STAFF RECOMMENDATION 2308 Belmont Boulevard November 16, 2016

Application: New construction- addition; Partial demolition
District: Belmont-Hillsboro Neighborhood Conservation Zoning Overlay
Council District: 18
Map and Parcel Number: 10416037600
Applicant: Tyler LeMarinel, Allard Ward Architects
Project Lead: Melissa Sajid, melissa.sajid@nashville.gov

Description of Project: The request is to construct rear addition. The applicant also proposes to install front porch brackets; replace damaged front stoop, steps, and site walls; and to infill a window on the right side of the house.

Figure 3: Window to be infilled on right side elevation

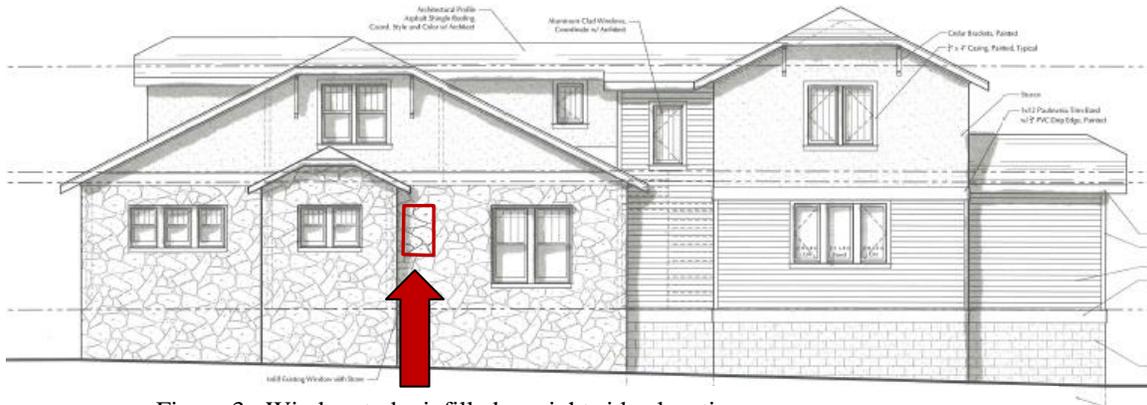
The request includes removing and infilling the existing double-hung window on the right side of the historic house (Figure 3). The window to be altered is located on the right side of the historic house, behind the existing bay window. Staff finds that removing this window could be appropriate since it is located behind the midpoint of the historic house and is obscured by the existing bay window which projects out from the side wall by approximately four feet (4'). For these reasons, this alteration is unlikely to be seen from the street. In addition, the applicant has indicated that the stone removed from the

existing rear elevation to allow for the addition will be used to fill in this opening. No other changes to the dimension and design of the existing openings are proposed.

With the condition that staff review and approve the roof color, porch steps, porch floors, porch railing, front site walls, windows, and doors as well as the masonry color, dimensions, and texture for the window that is to be infilled on the right side of the historic house prior to purchase and installation, the project meets section II.B.1.d.

Site Layout Plan
 Scale: 1" = 20'-0"

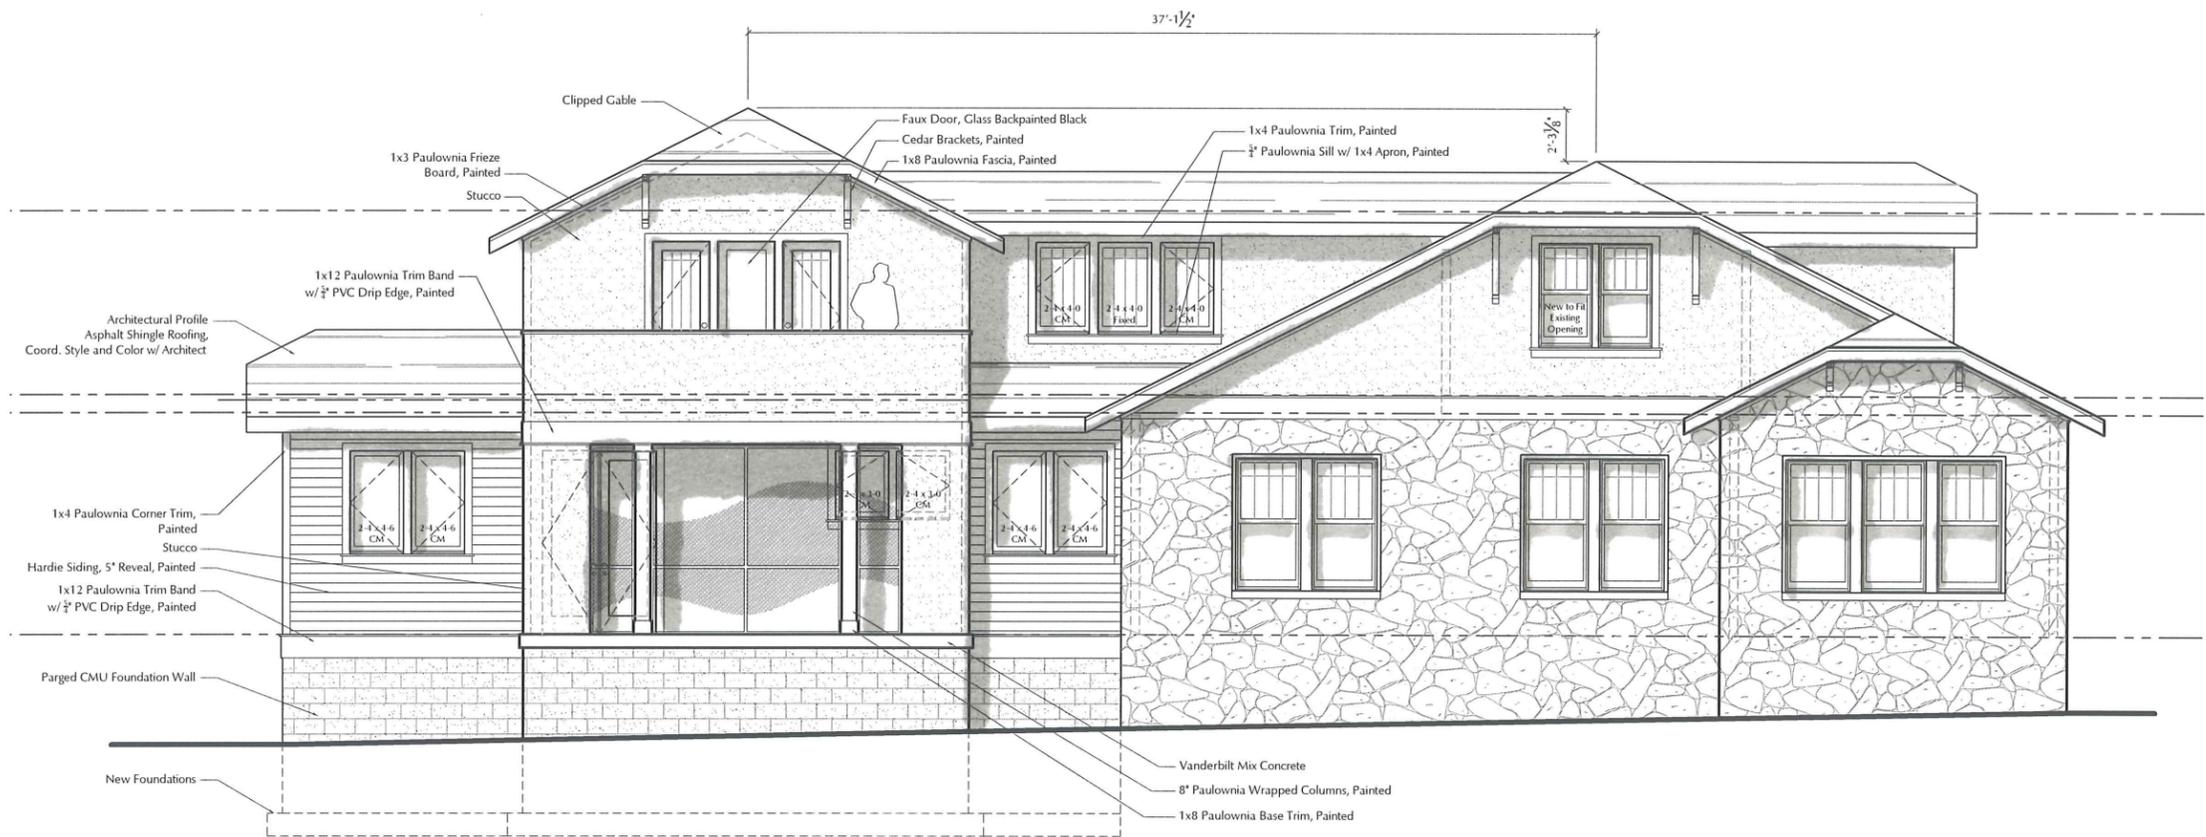
Setbacks: The new addition meets all setbacks required by the base zoning. The addition is located approximately fifty-two feet, five inches (52'-5") from the rear property line, five feet (5') from the right side property line, and fourteen feet (14') from the left side property line.

1 North Elevation
 Scale: 1/8" = 1'-0"

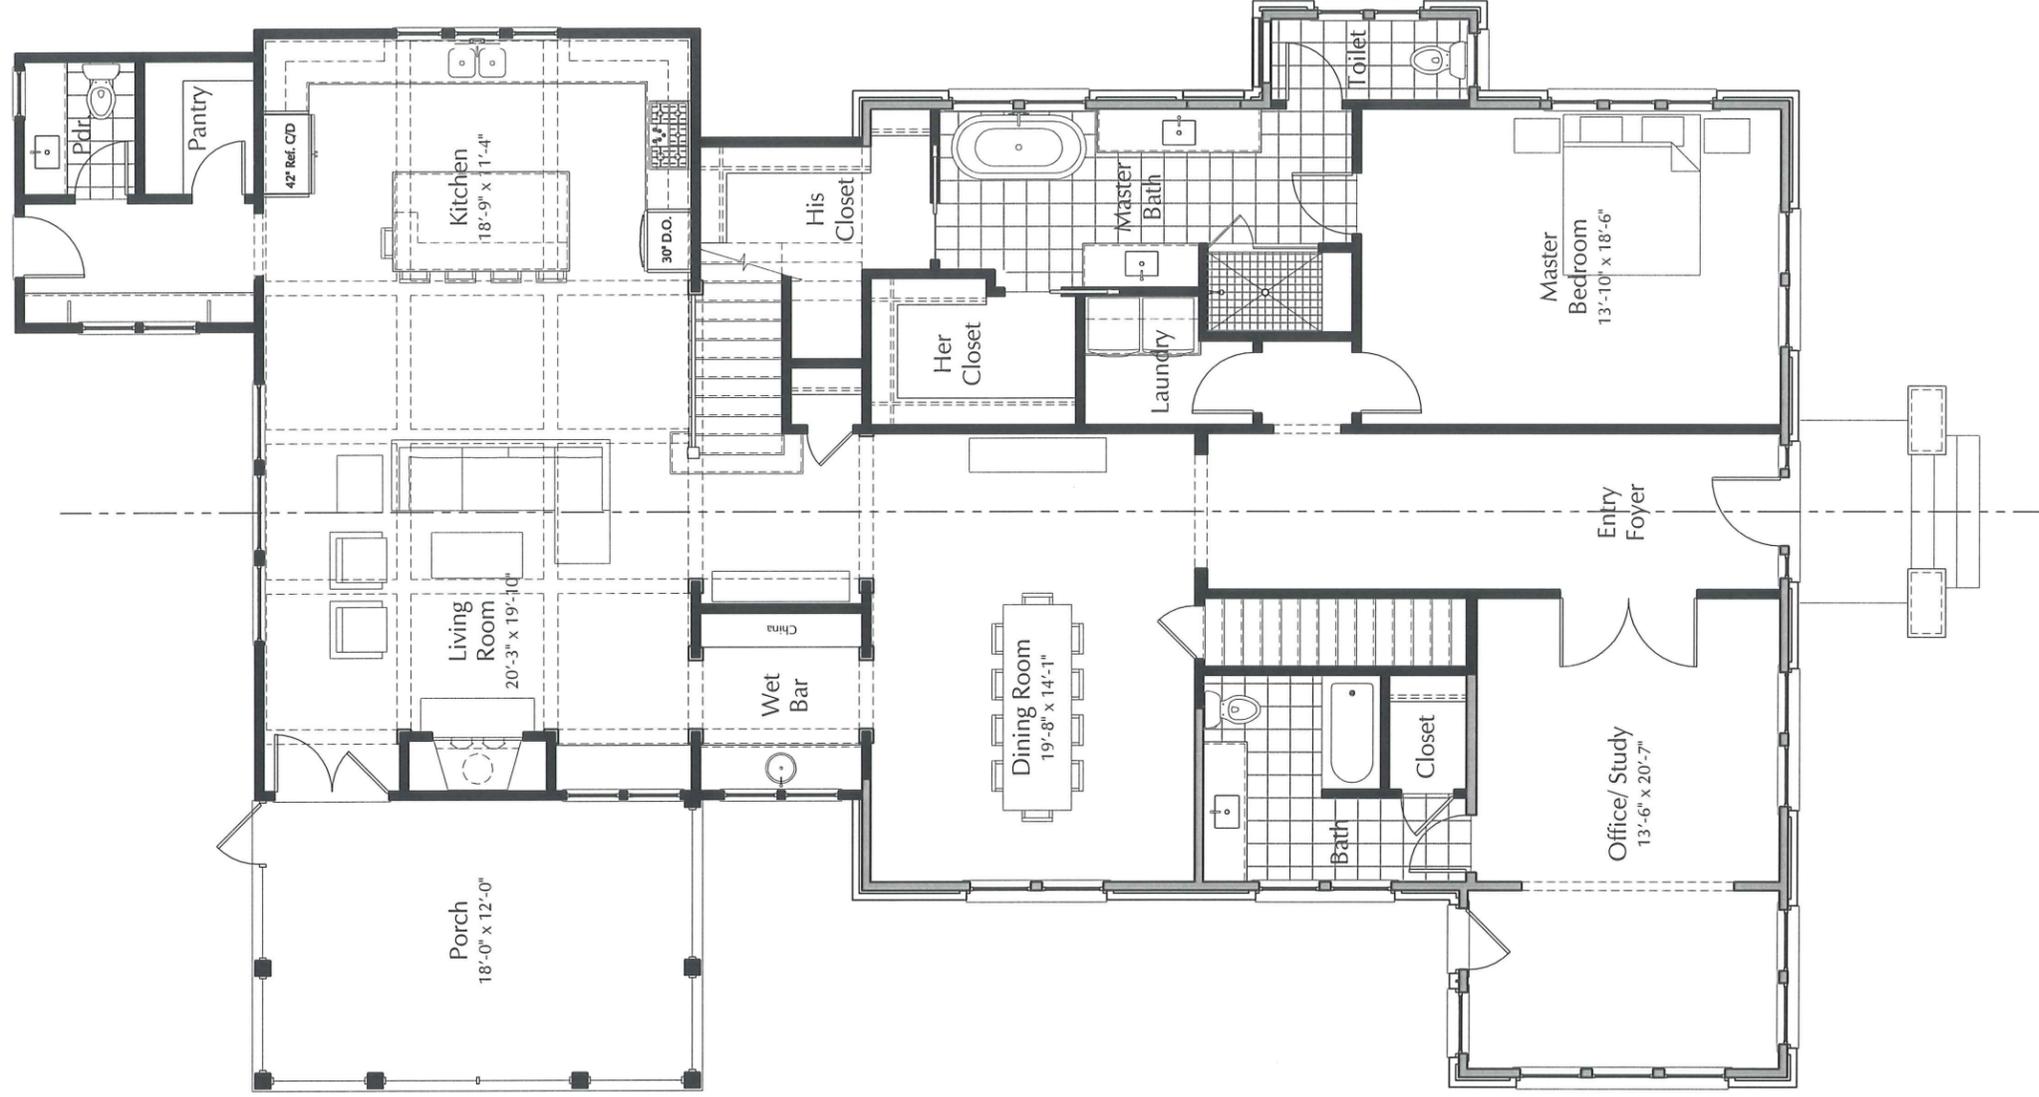
As proposed, the addition is approximately two feet, three inches (2'-3") taller than the historic house, and the additional height is located approximately fifty-nine feet (59') from the front wall of the historic structure. The design guidelines allow additions to be up to four feet (4') taller than a historic structure when the additional height is located at least forty feet (40') from the front edge of the existing building and only when additional height is needed. Although it does not appear that additional height is required, staff finds that the proposed is appropriate as it is located more than forty feet (40') from the front edge of the existing building and only a small portion of roof will likely be visible from the street. The additional height does not span the entire width of the building, and most of the section above the existing roof will be roofing which helps to minimize the visibility of the addition. In addition, the footprint of the addition is relatively modest compared to the footprint of the historic structure.

The proposed rear addition does not more than double the footprint or depth of the historic structure. In addition, staff finds the proposed additional height is appropriate as it does not exceed four feet (4'), is located fifty-nine feet (59') behind the front wall of

Roof form: The roof form of the addition is cross gabled, with pitches and clipped siding-facing gables that complement the existing historic house. The addition ties into the existing side-gabled roof six inches (6”) below the ridge. Staff finds that the proposed roof form is compatible with the historic house and meets section II.B.1.e.
